CLUB DE GOLF LOS LEONES LAS CONDES - SANTIAGO - CHILE

SITE REPORT FOLLOWING VISIT IN JANUARY 2011

A D A M G O L F D E S I G N ARQUITECTOS DE CANCHAS DE GOLF

PROPOSED VIEW OF THE GREEN AREA - HOLE N°15

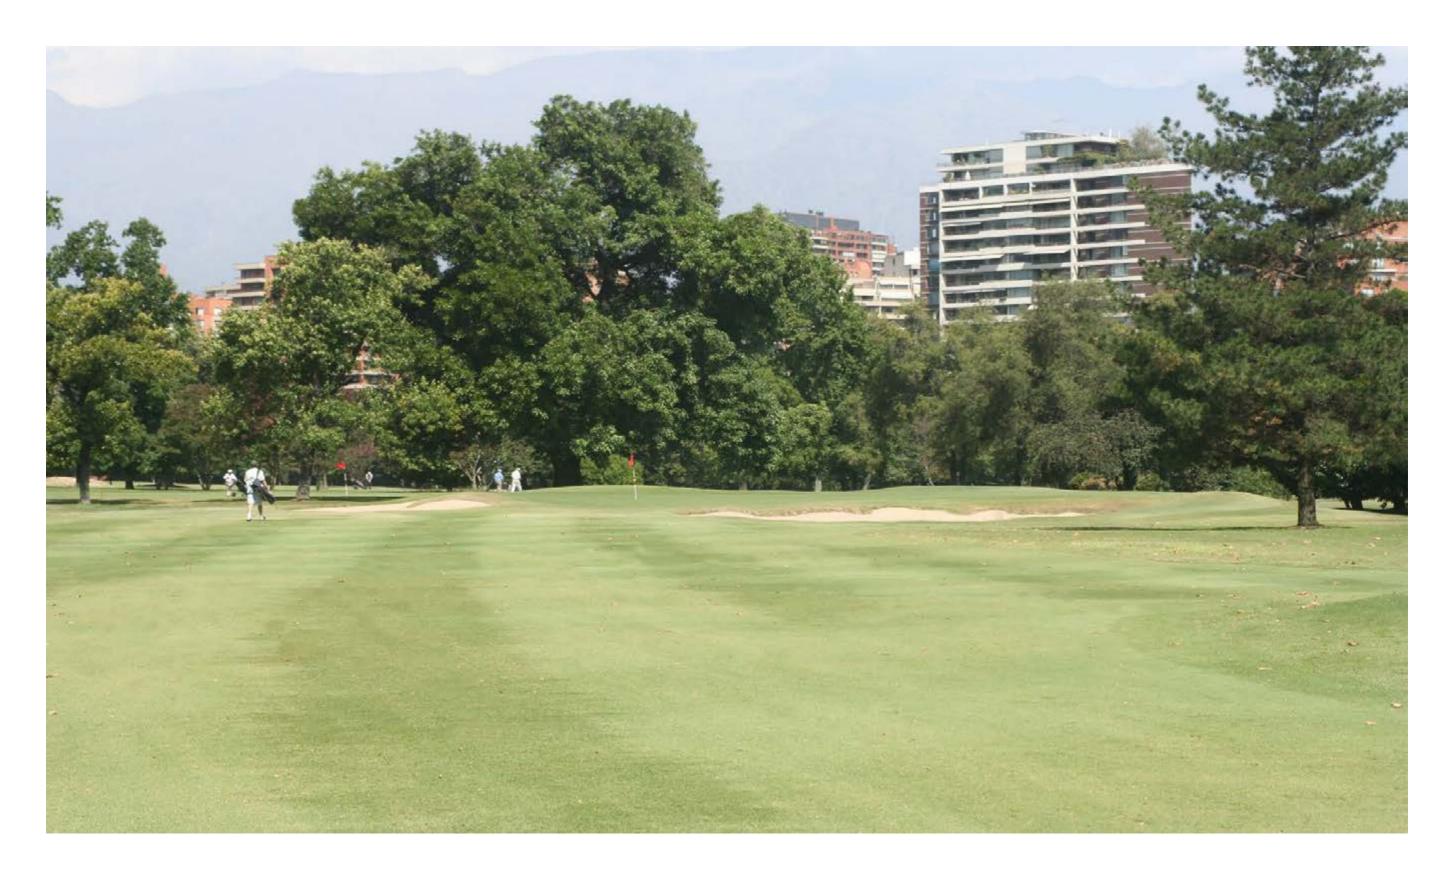
At present the left and right green bunkers are not really visible. The banks of the bunkers also need to be softened to facilitate maintenance.

We propose to soften the bank of the left and right green bunkers by filling within and to raise the sand lines to make the bunkers more visible and to make the green complex more visually appealing.

EXISTING VIEW OF THE GREEN FROM THE 2ND LANDING AREA - HOLE N°17

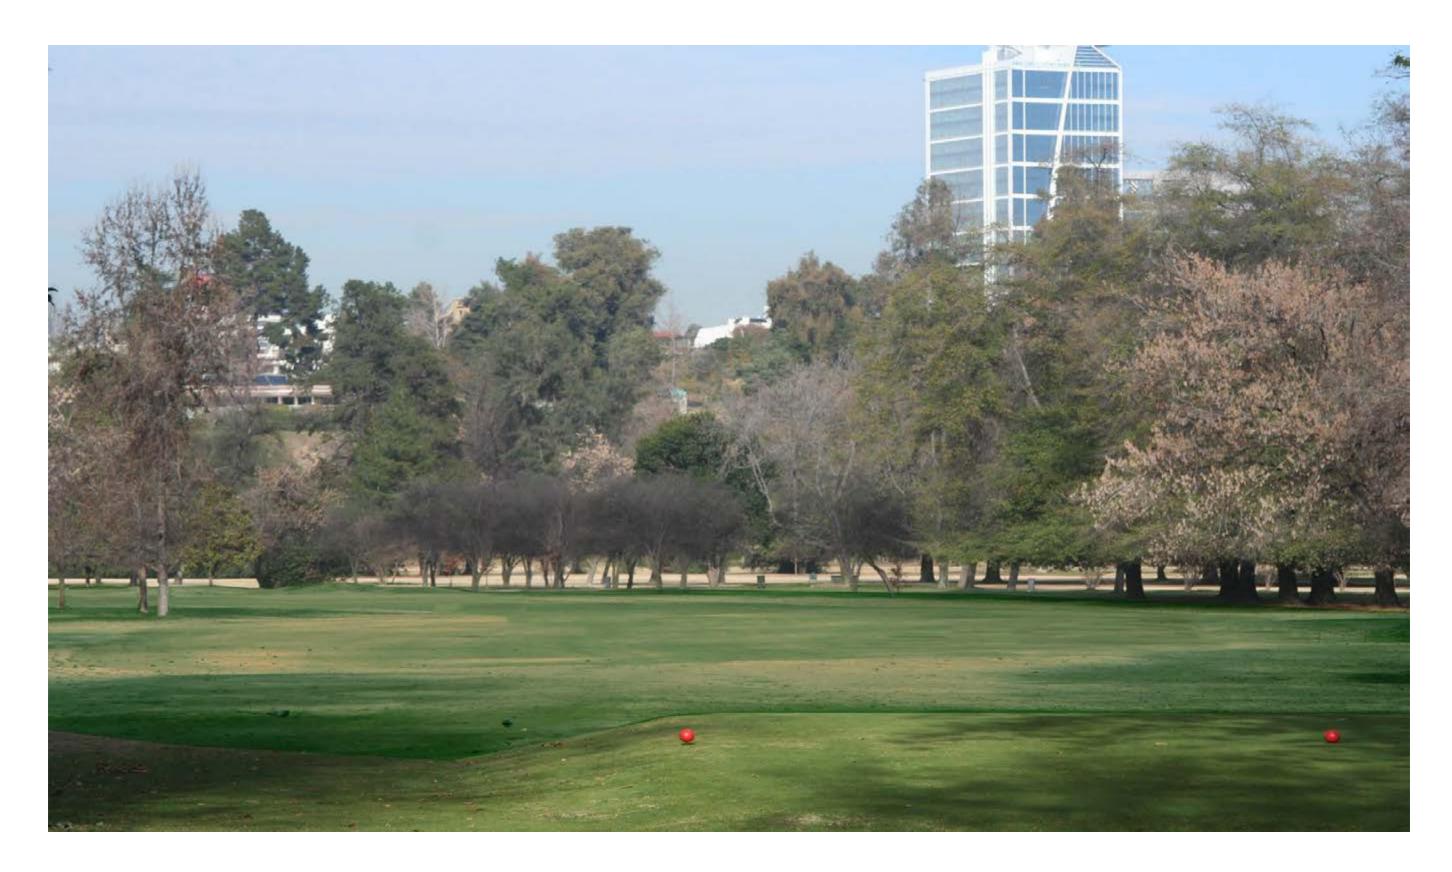
At present the fairway bunker on the right side of the 2nd landing area is completely flat and invisible. As I understand it, this bunker was placed to complicate the landing area for those in the trees on the right side of the 1st landing area. It's intent is to complicate the recovery shot. The front green bunker is not very visible. The right green bunker is visible but it appears as a horizontal line on the horizon. The back green bunker could be made more visible.

We propose that this bunker be made much more visible by the placing of a mound behind the bunker and raising the sand line. Nevertheless I question the validity of this bunker! We also propose to raise the sand line of the front green bunker. We also propose to place a mound behind the right side of the right green bunker to help make it more visible and to give some visual movement to the bunker. We also propose to increase the height of the existing mound into the bunker to help make the bunker more visible and to also create greater movement for this bunker.

EXISTING VIEW FROM THE 1st LANDING AREA - HOLE N°18

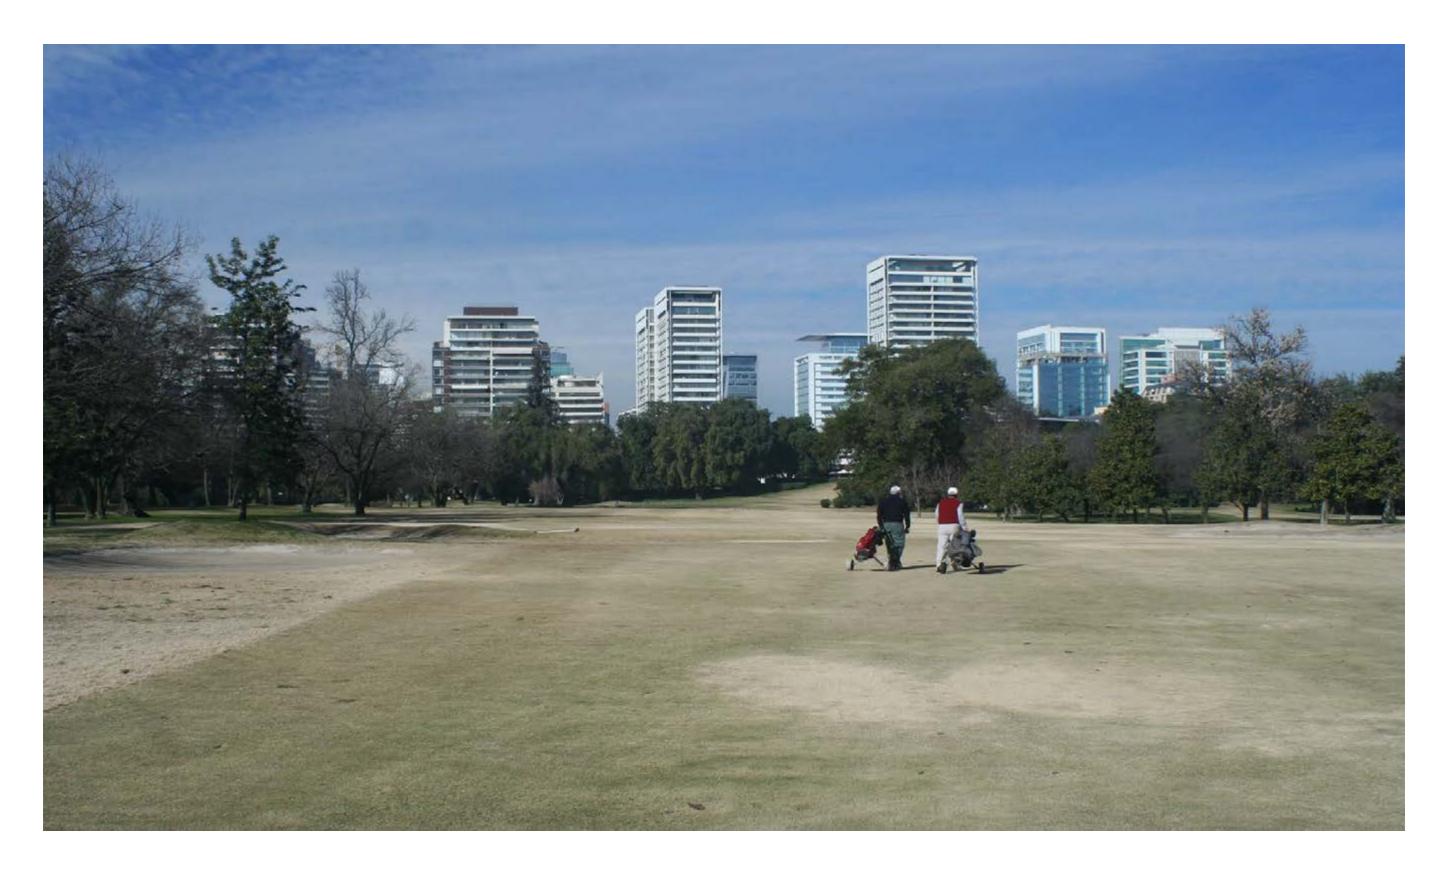
At present the fairway bunkers are not really visible and loose in their strategic and aesthetic value.

We propose to place some mounding behind the existing fairway bunkers to make the bunkers more visible and to help raise the sand line.
